R6			R4			R2			SIGN	NAME	<b>GENERAL ARRANGEMENT DRAWINGS</b> <b>145 KV CURRENT TRANSFORMER</b> <b>TYPE-IOSK:145/275/650</b>	 CG Power and Industrial Solutions Limited, Aurangabad	
R5			R3		R1			DRN	SSM				
								CHD	SSM				
NO	REVISION	SIGN/DATE	NO	REVISION	SIGN/DATE	NO	REVISION	SIGN	DATE	SCALE	N.T.S. DATE: 20.05.2021	ALL DIMENSIONS ARE IN mm	DRG.NO: 145CT HC 800-500-1A GA/R0

R6			R4			R2				SIGN	NAME	SECTIONAL VIEW DRAWING FOR 145 kV CURRENT TRANSFORMER TYPE-IOSK:145/275/650	 CG Power and Industrial Solutions Limited, Aurangabad		
R5			R3			R1			DRN	SSM	ALL DIMENSIONS ARE IN mm				
								CHD	SSM						
								APPD	SDS						
NO	REVISION	SIGN	DATE	NO	REVISION	SIGN	DATE	NO	REVISION	SIGN	DATE	SCALE	N.T.S.	DATE : 20.05.2021	DRG.NO:-145CT HC 800-500-1A SV/R0

R6				R4				R2				SIGN	NAME	<b>RATING &amp; SCHEMATIC DIAGRAM</b> <b>FOR 145 KV CURRENT TRANSFORMER</b> <b>TYPE-IOSK:145/275/650</b>		
R5				R3			R1				DRN	SSM				
											CHD	SSM				
											APPD	SDS				
NO	REVISION	SIGN	DATE	NO	REVISION	SIGN	DATE	NO	REVISION	SIGN	DATE	SCALE	N.T.S.	DATE : 20.05.2021	ALL DIMENSIONS ARE IN mm	DRG.NO:- 145CT HC 800-500-1A RS/R0

R6			R4			R2			SIGN	NAME	SECONDARY BOX ASSEMBLY FOR 145 kV CU

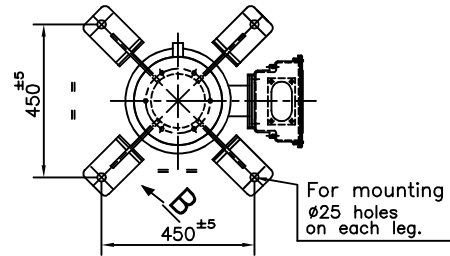
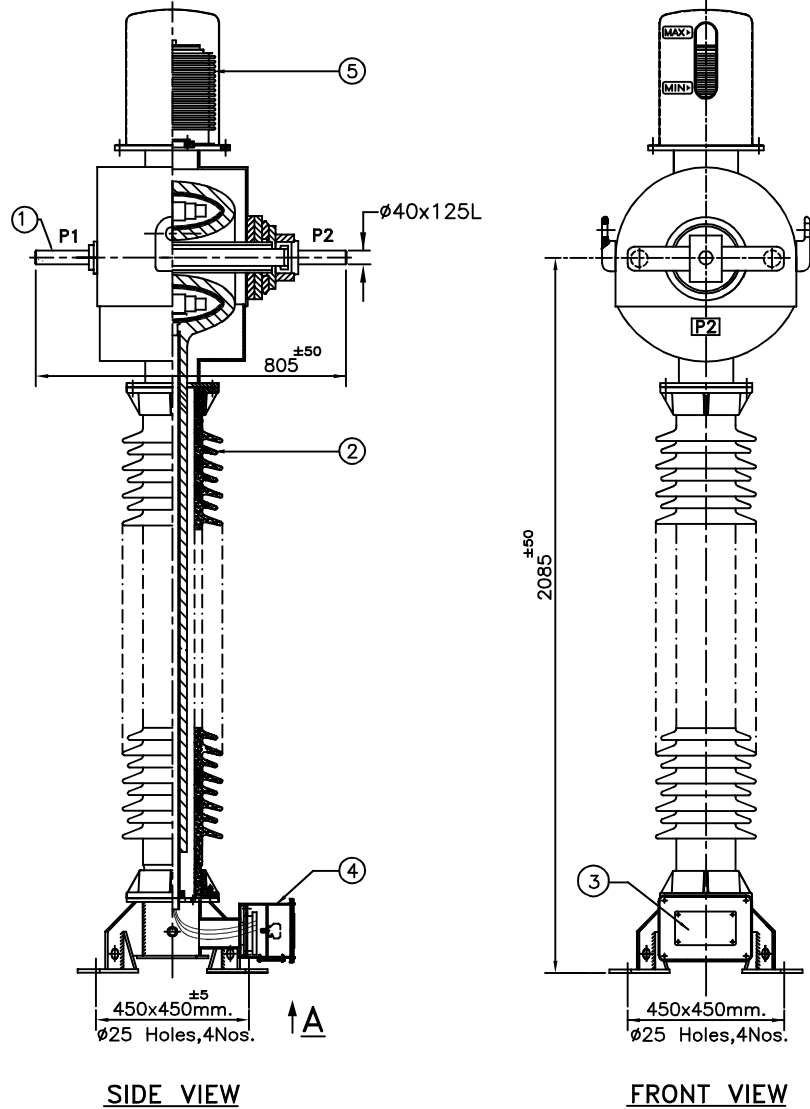
1). Minimum 300 mm Plinth shall be maintained for Current transformers in the substation during foundation works to ensure safe live to ground clearances as per IE rules.

2). Since the supply of terminal connectors is not in the scope of CT Manufacturer as mentioned in the drawings, the EPC contractors shall be instructed to supply the same in line with the CT requirement and compatibility.

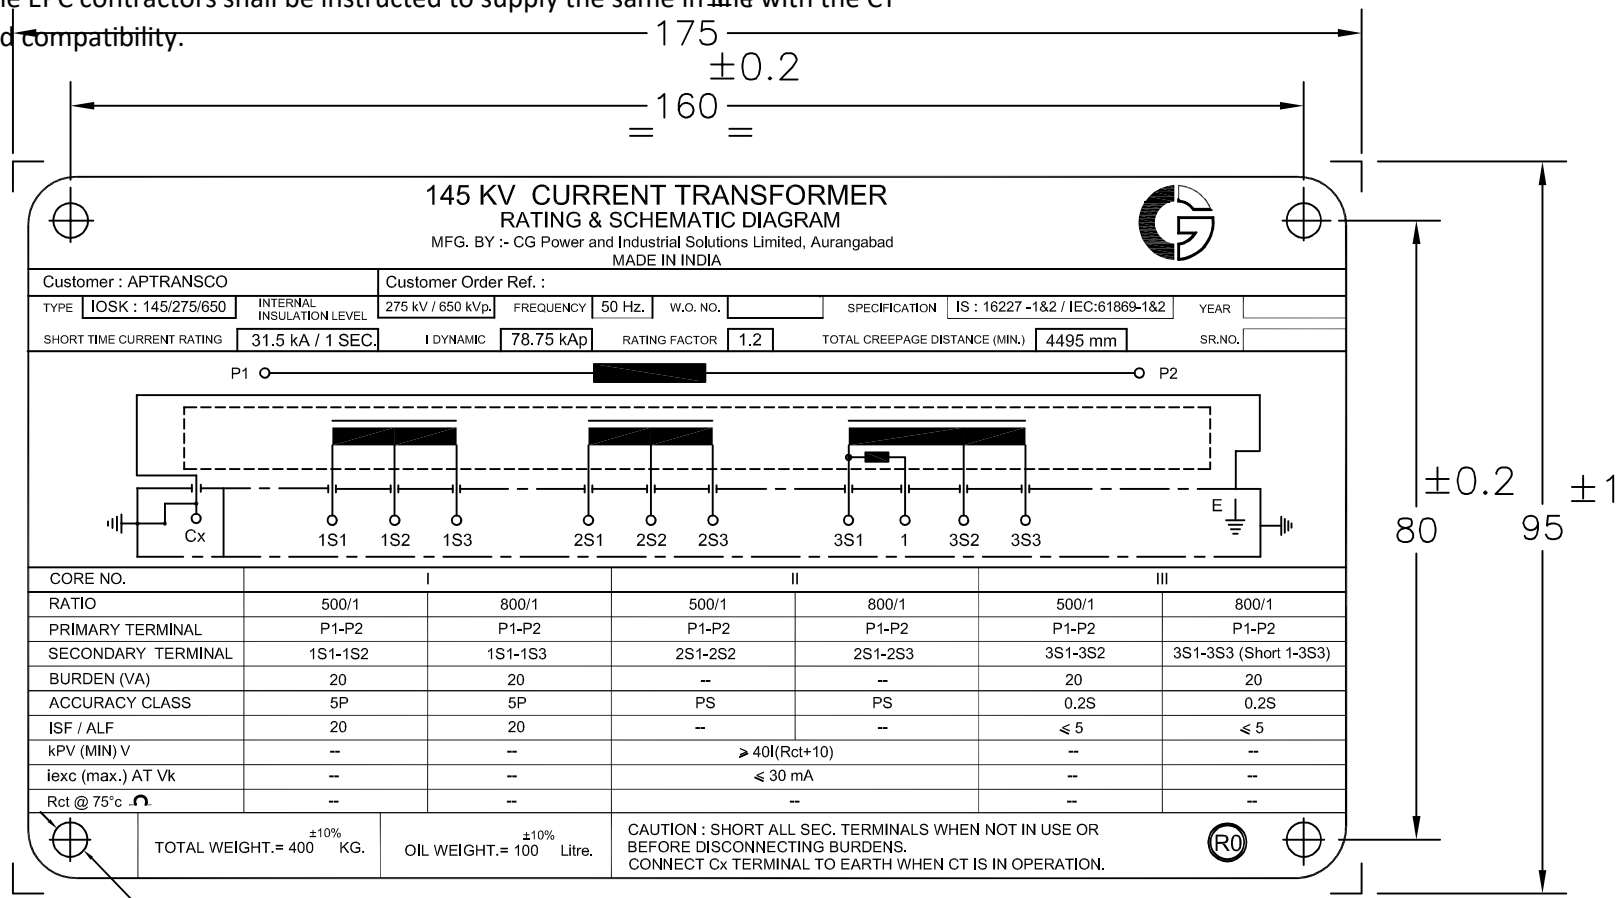
NOTE : DRAWING APPROVAL SUBJECT TO VALID TYPE TEST REPORTS, TO BE CHECKED DURING ACCEPTANCE TESTS.
